# Kiely Arborist Services

Site: 851 Sierra Vista, Mountain View, CA

## Addendum:

The Developer recently informed me that they will need to remove Trees #2 and #4 on site, due to the Joint Trench Line and the Utility Boxes that cannot be moved.

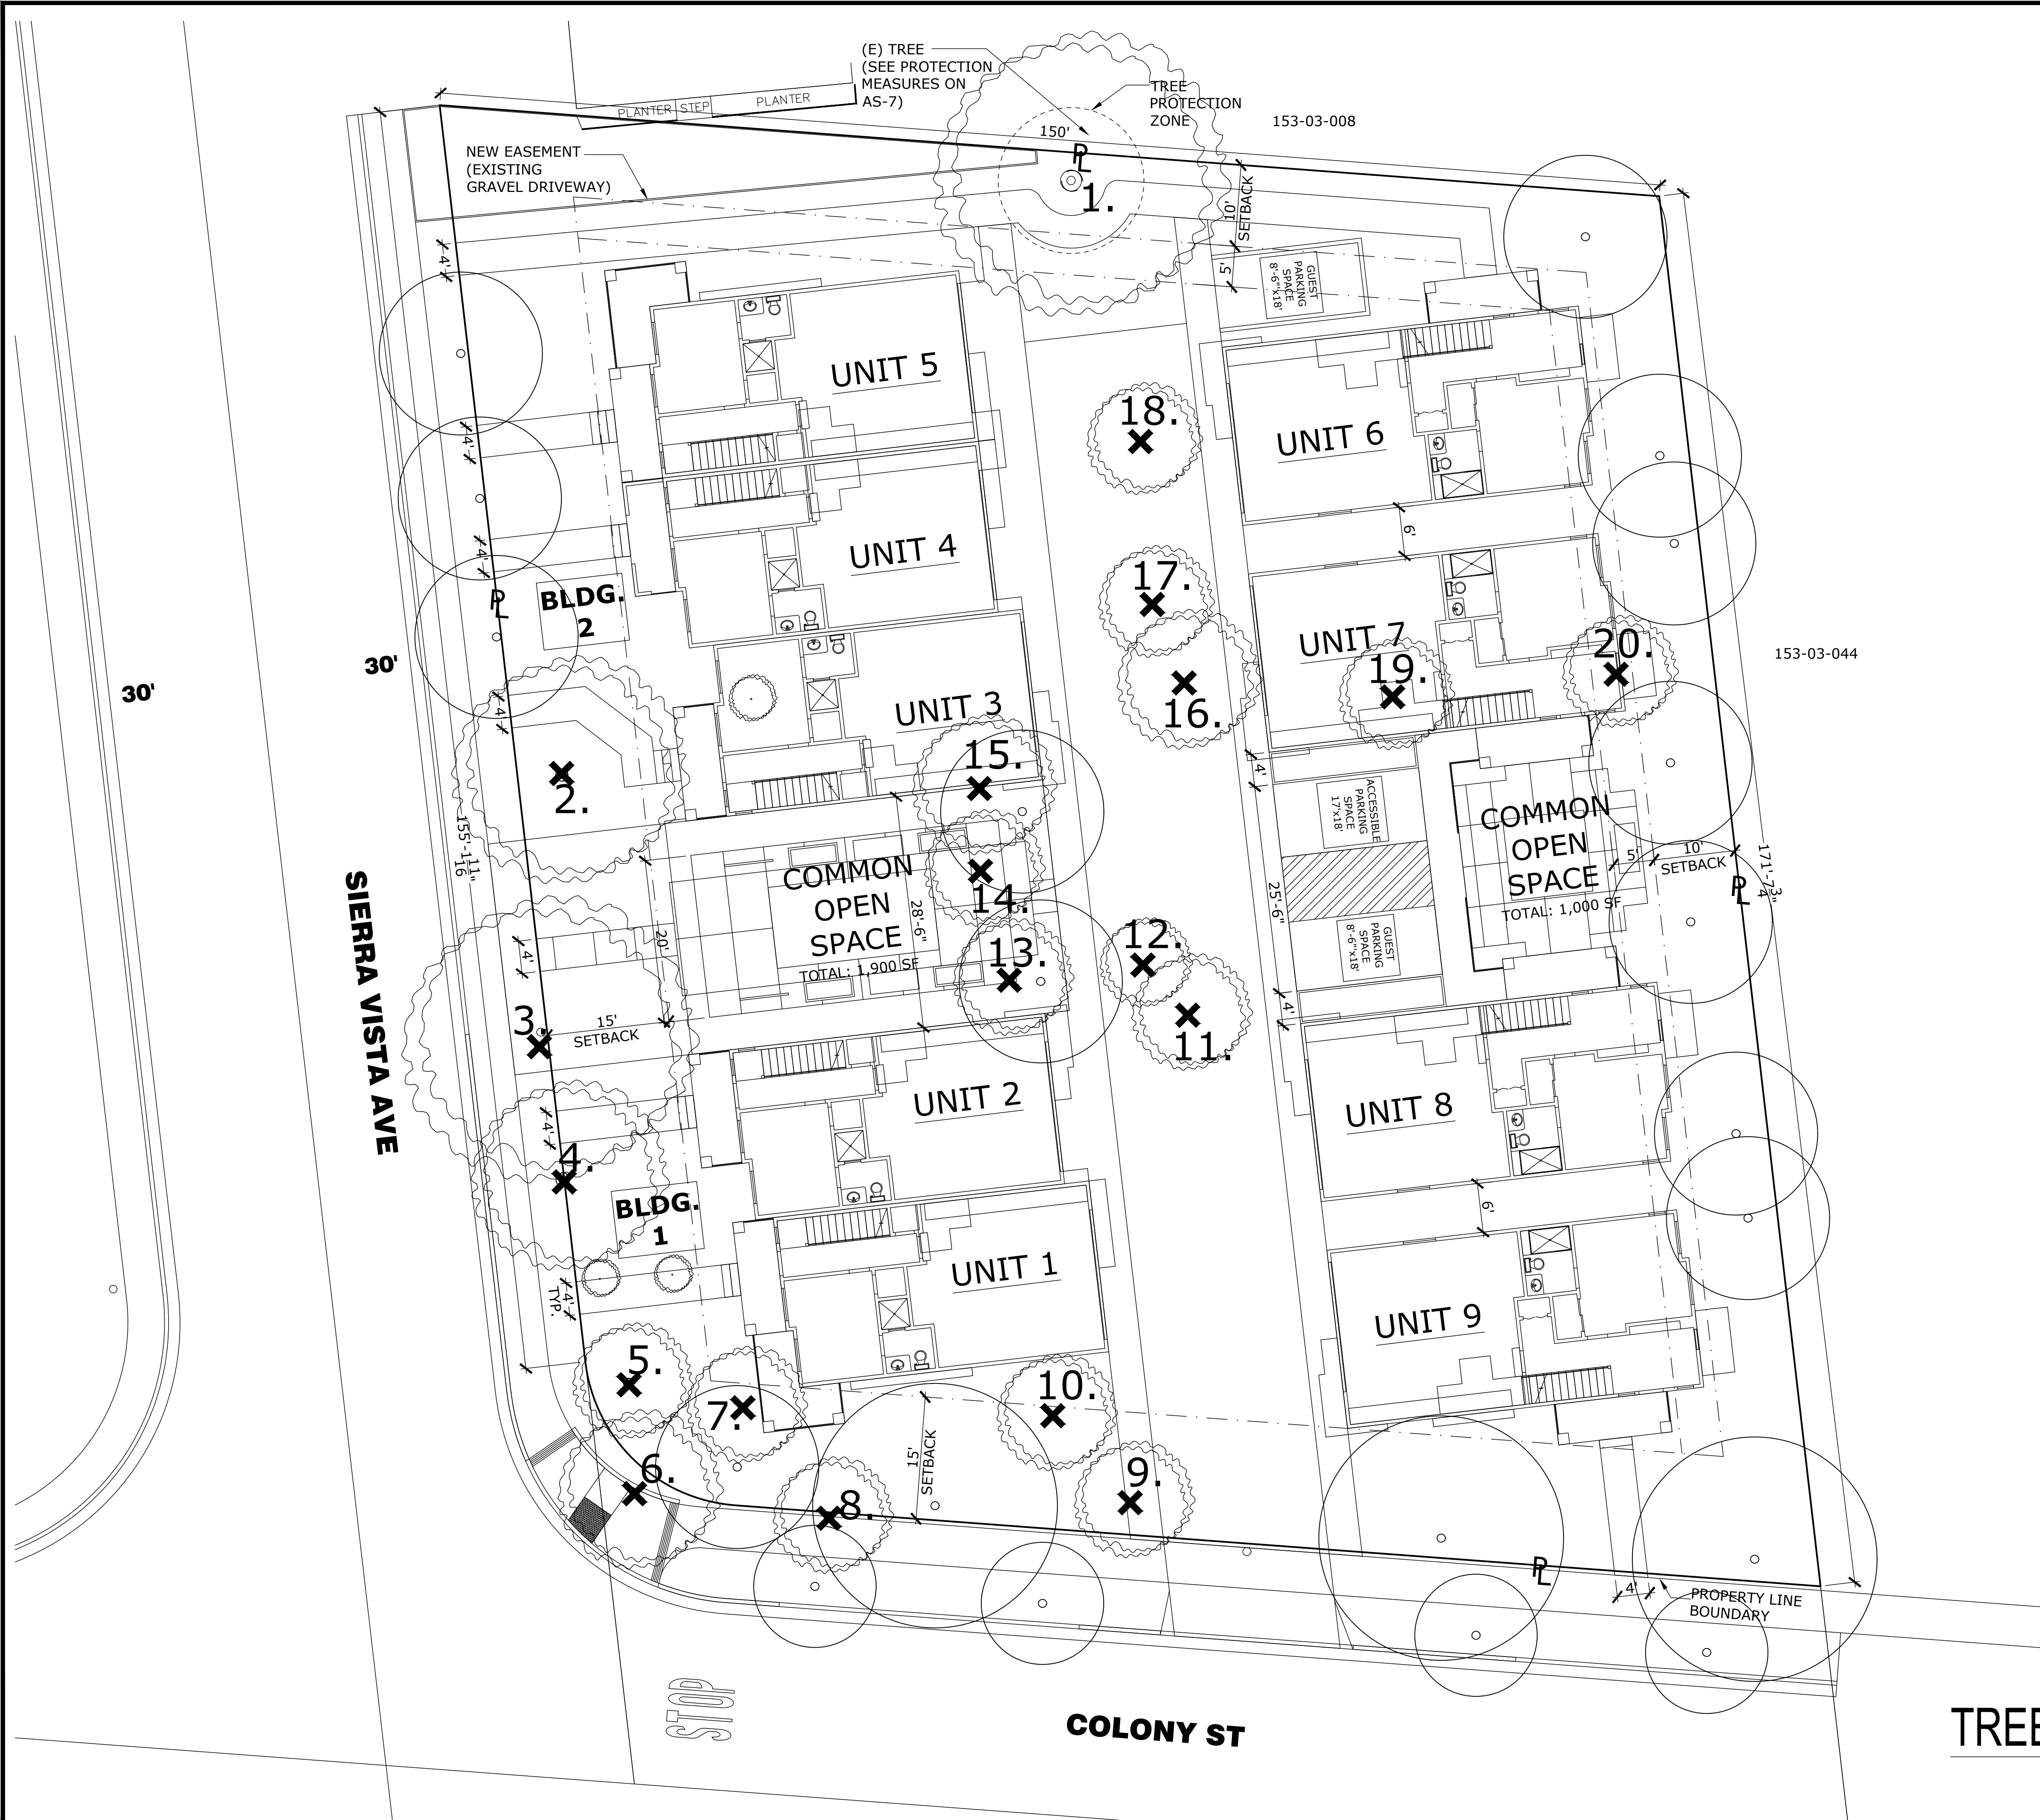
Tree #4 was already recommended for removal due to its fair/poor condition and possible impacts. Tree #2 also had major impacts because of its proximity to the existing berm. Given the amount of work being done and its proximity to these 2 trees, I would recommend removal for both.

**TREE PLAN**

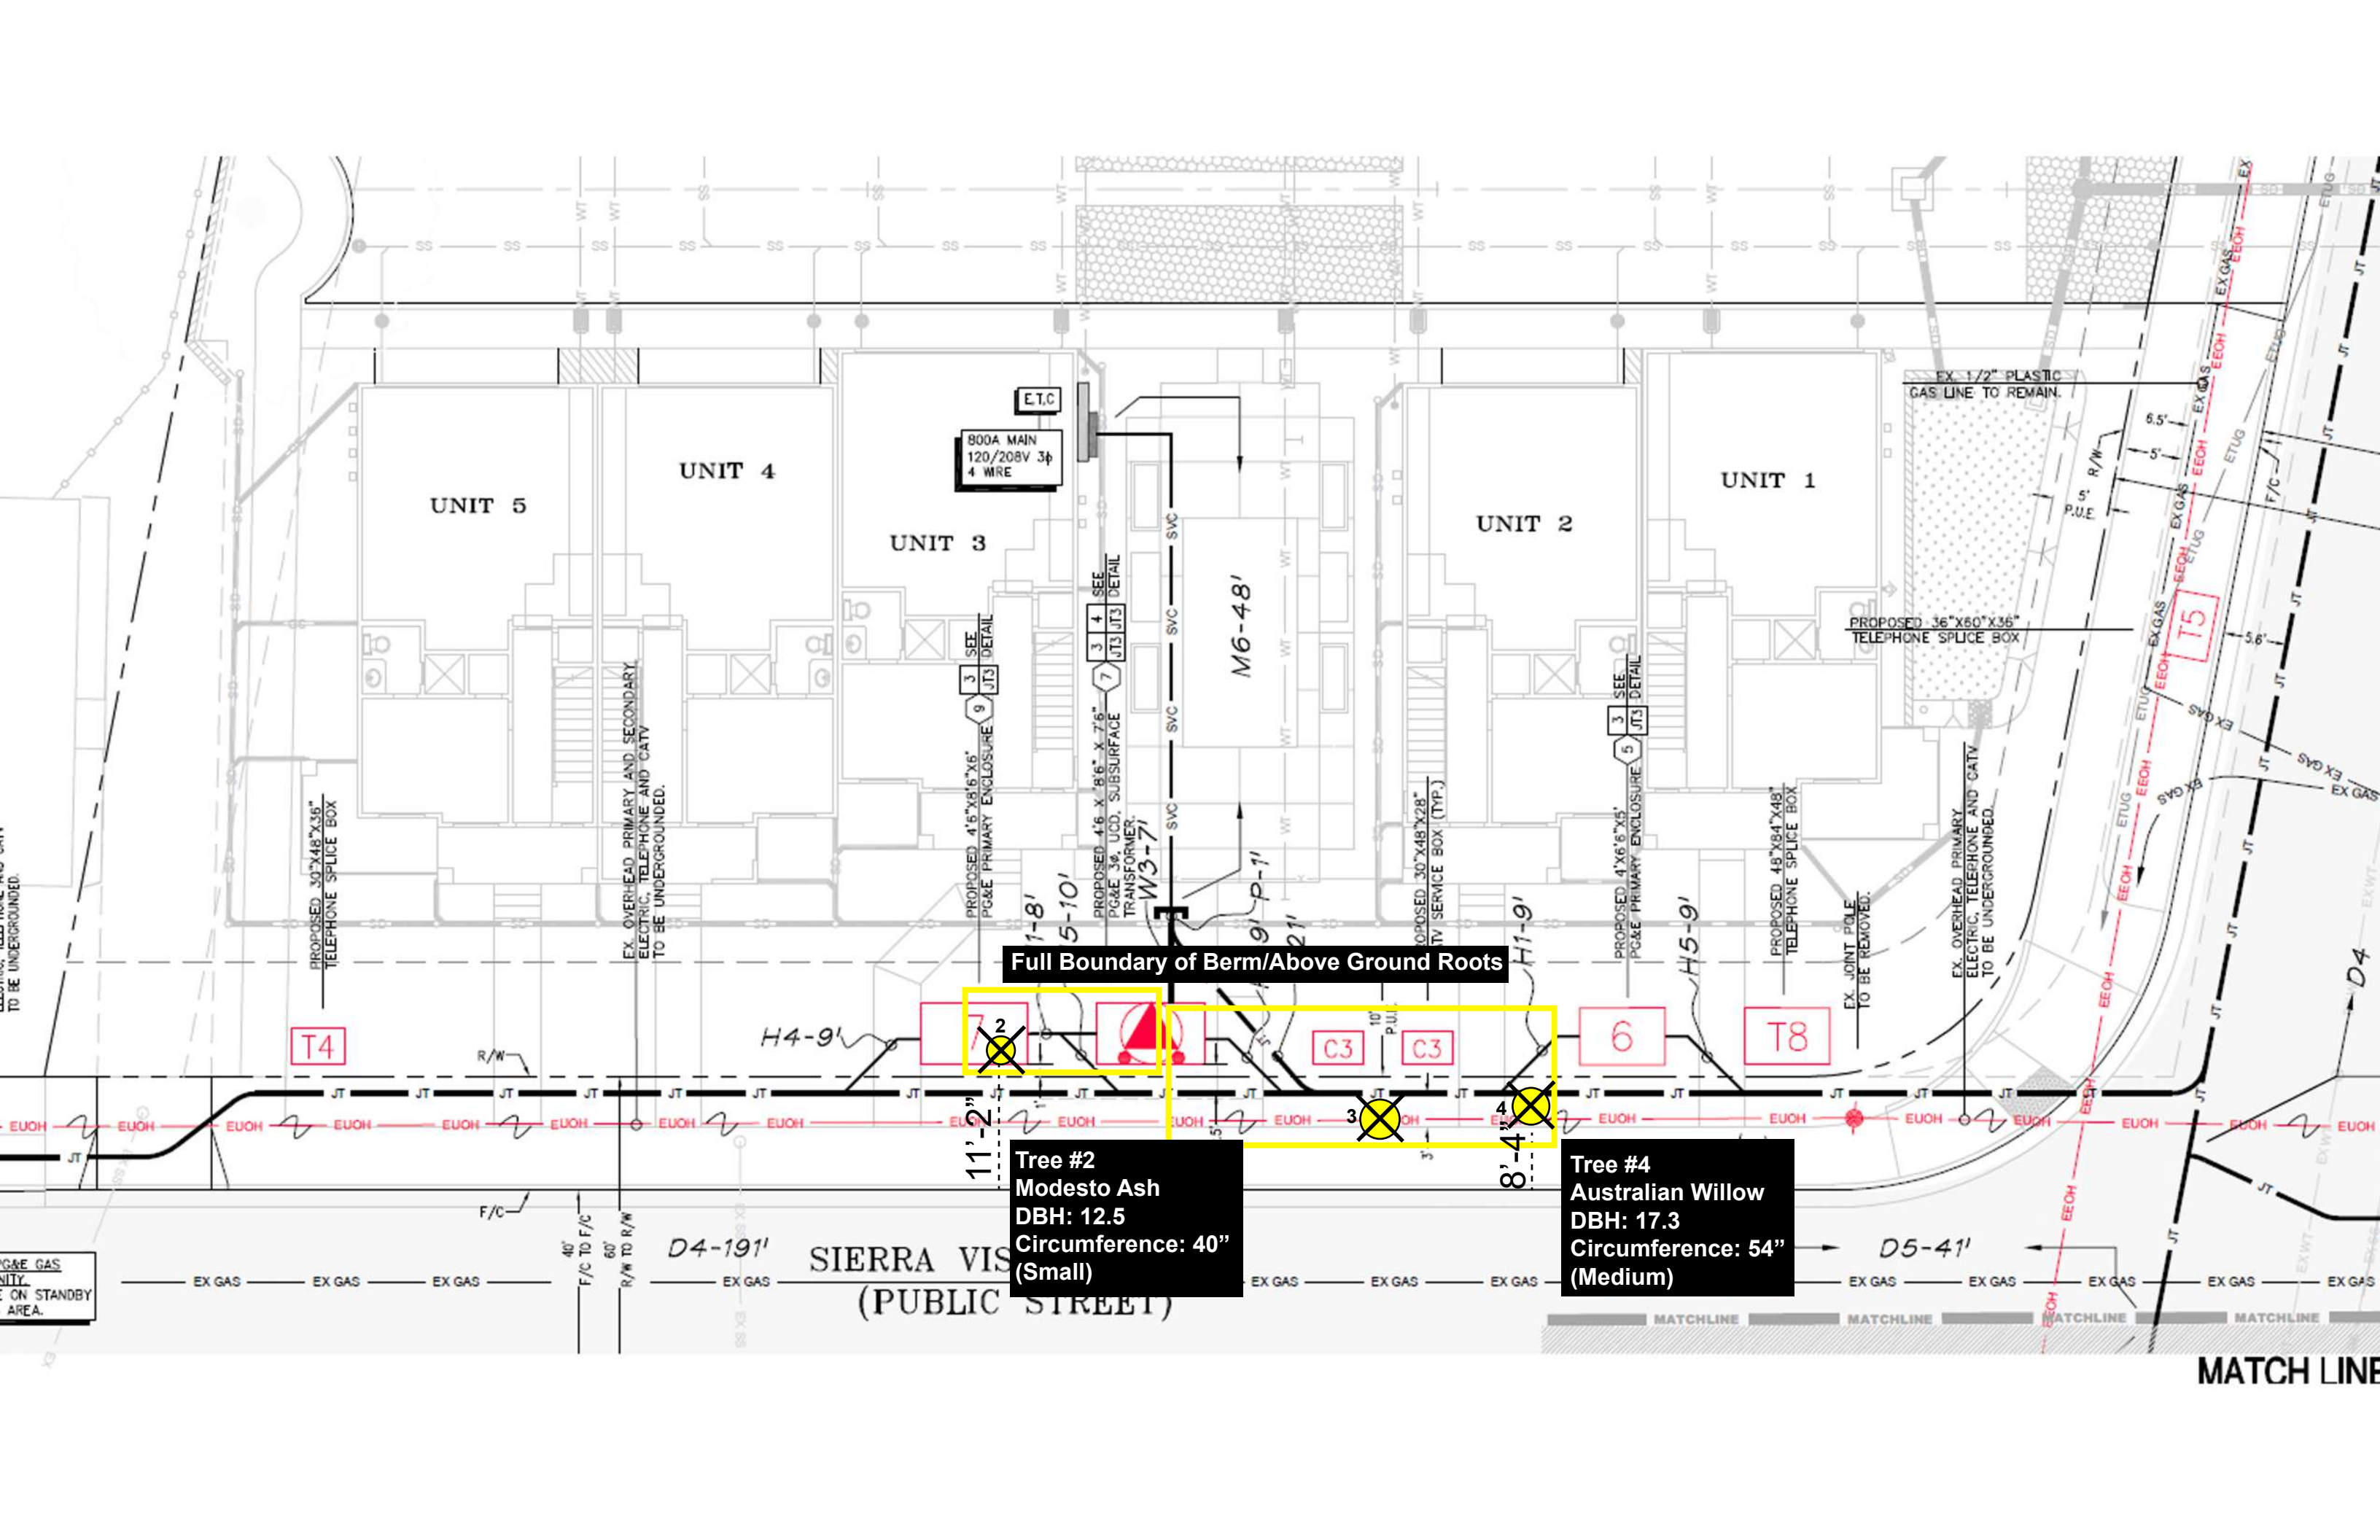
**Full Boundary of Berm/Above Ground Roots**

**Tree #2  
Modesto Ash  
DBH: 12.5  
Circumference: 40"  
(Small)**

**Tree #4  
Australian Willow  
DBH: 17.3  
Circumference: 54"  
(Medium)**
